ENGINEERING ALTERNATIVES REPORT (EAR)

**WESTBANK AND VICINITY, NEW ORLEANS, LOUISIANA
HURRICANE PROTECTION PROJECT
PHASE 2 HURRICANE PROTECTION
ALGIERS CANAL LEVEE WEST,
ALGIERS LOCK TO HWY. 23
WBV-47.2
B/L STA. 770+70 to STA. 978+18
ORLEANS AND PLAQUEMINES PARISHES, LOUISIANA**

95% SUBMITTAL

C-301-T

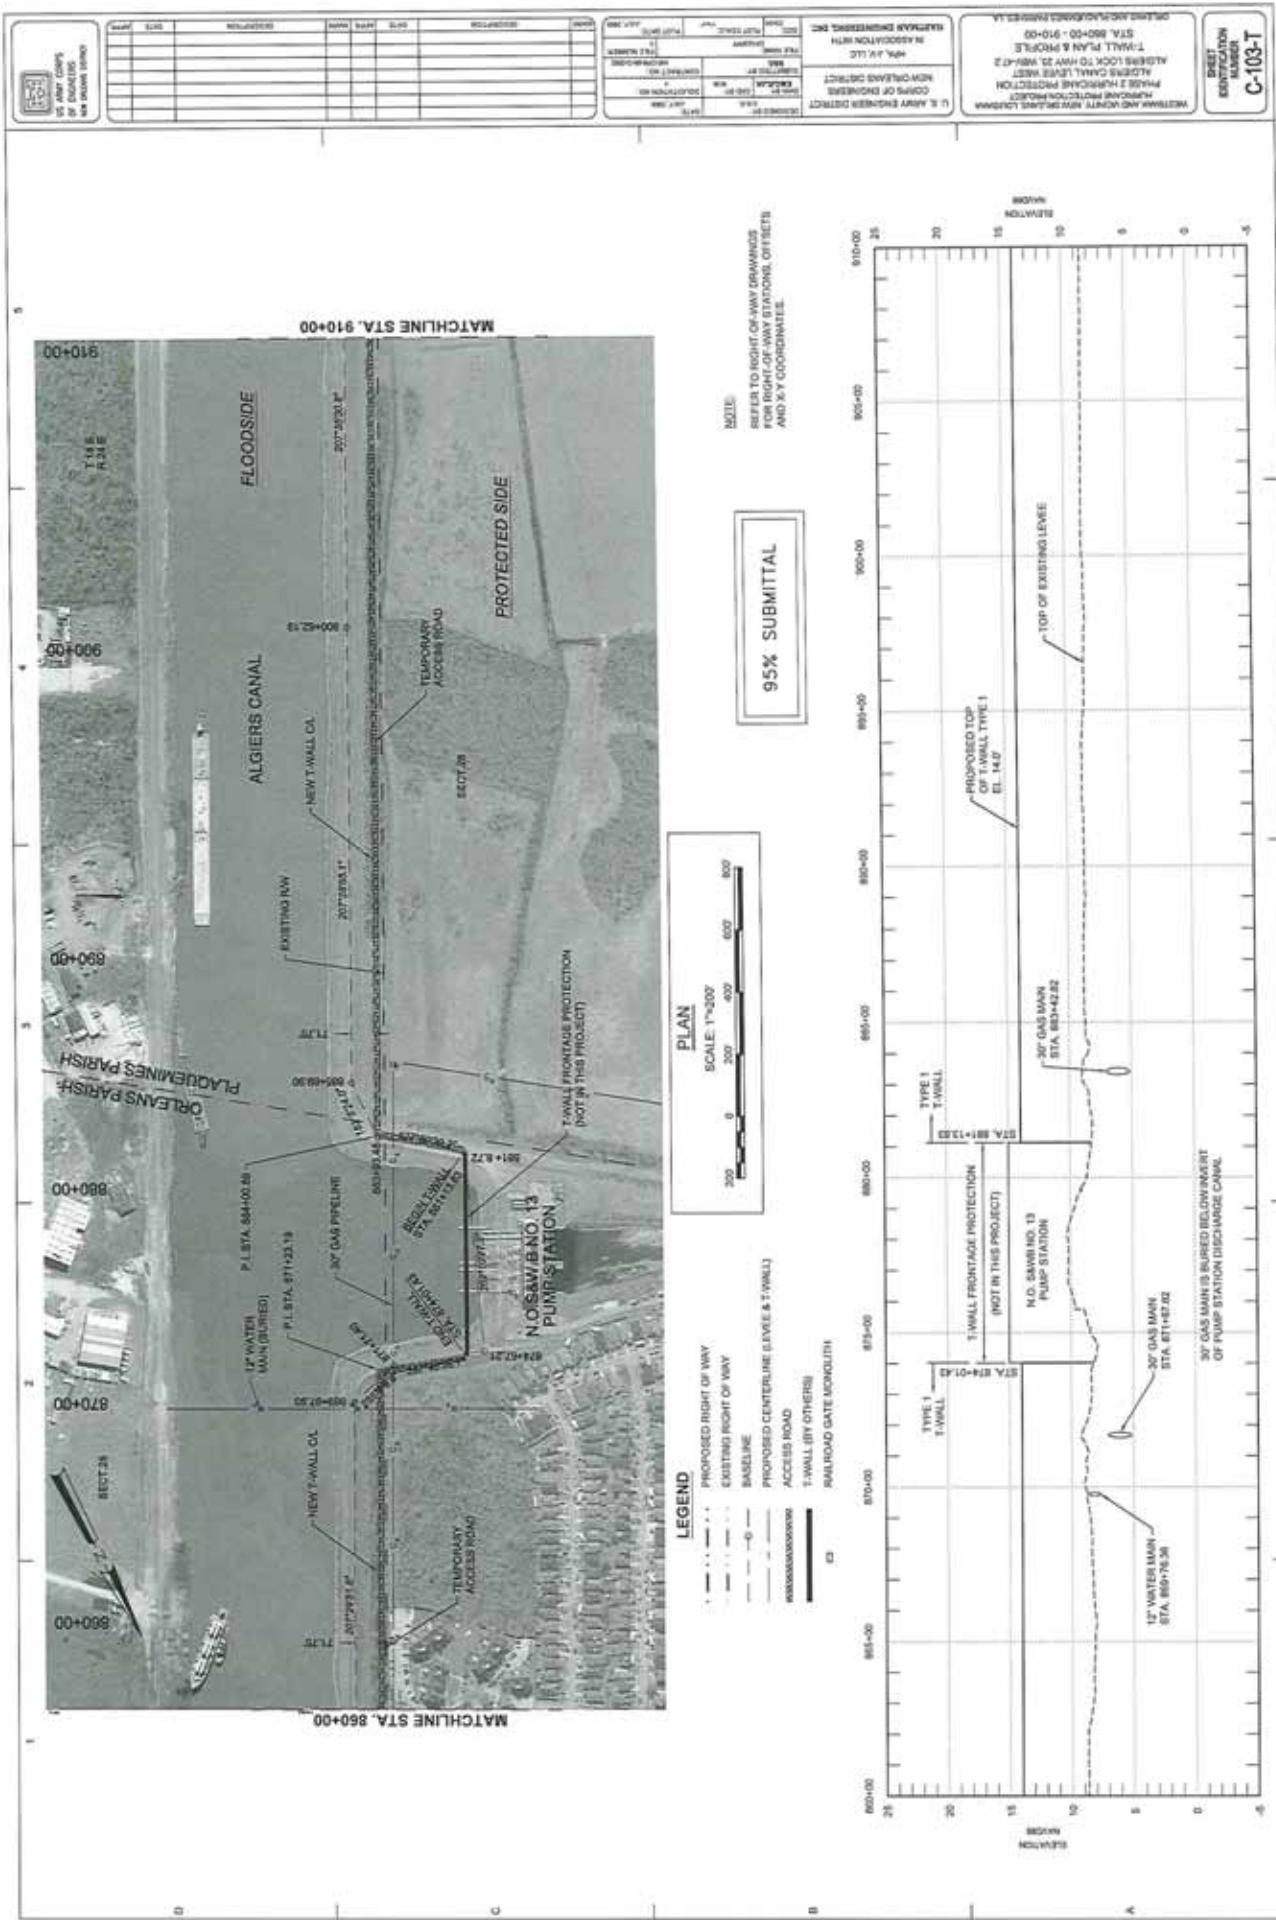
A reference to sheet C-301-T (typical section) would be helpful in the description of the design section.

It says "Per the Scope of Work, the existing levee will serve as a barge barrier; thus, impact loading from barge collision was not included as a load case". But, App. C, pg. 2 and 3 shows impact of 100k. Delete?? Or see dwg. C-301-T.

| Sheet C-301-T shows the existing levee to be cut to grade, whereas Page 5-3 and 6-10 call for this existing levee to be used as a barge barrier. Please clarify                                                                                                                                                                                                                                                  |                                                                                                                                                                                                                                                                                                                                                                                                                        |      |                  |     |

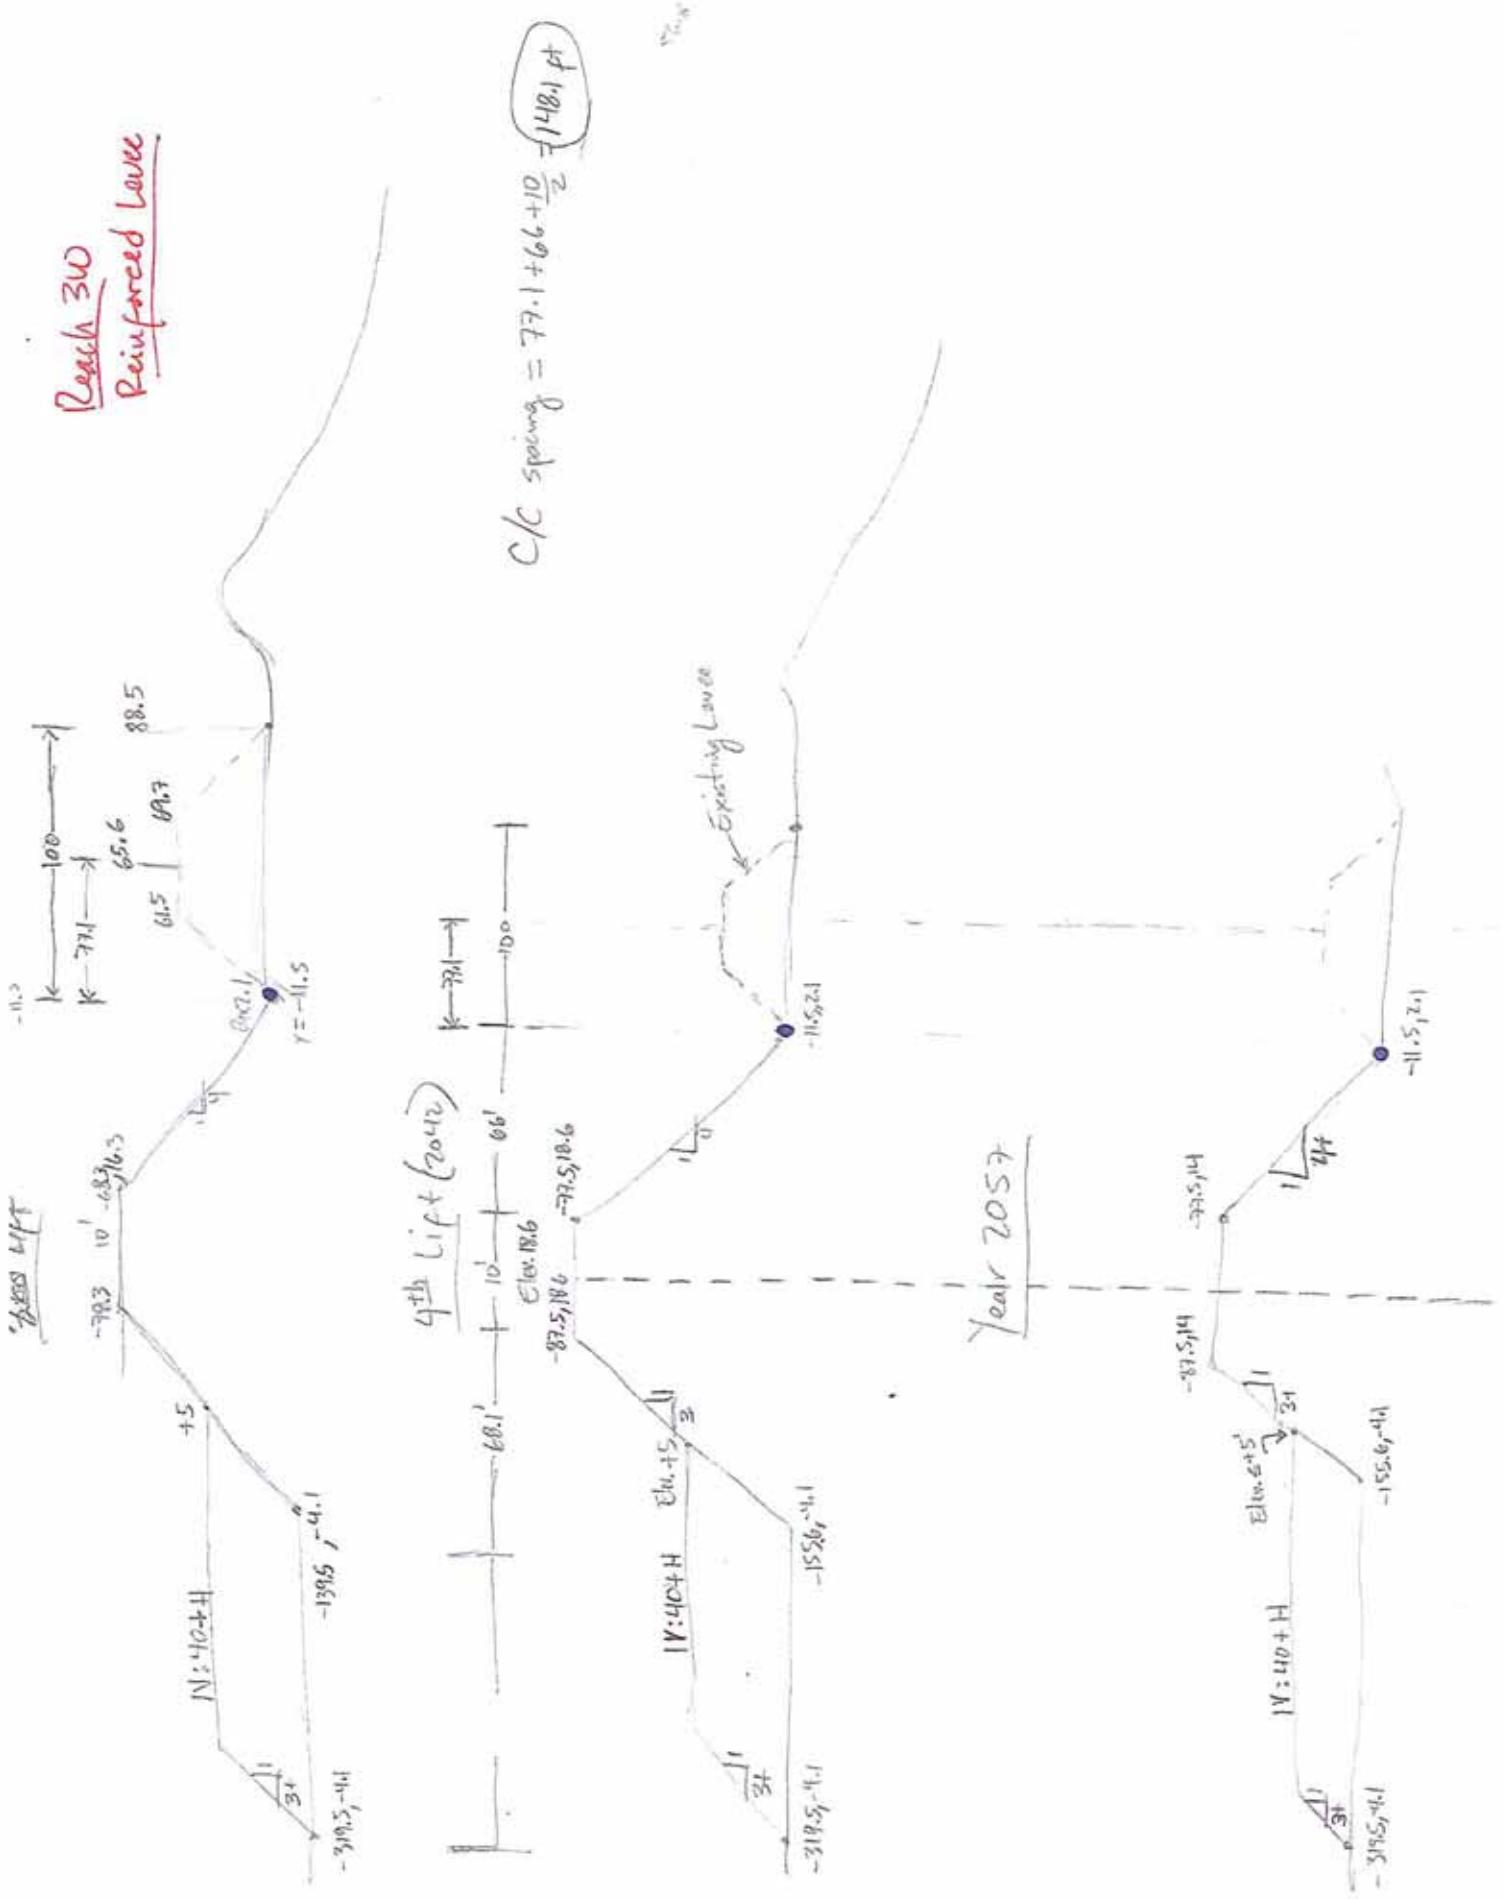
See my crude sketch for the Reach 3 levee at sta 850+00. My approx C/L to C/L spacing is 180-feet. Carlos has it shown on his sketch at 148.1.
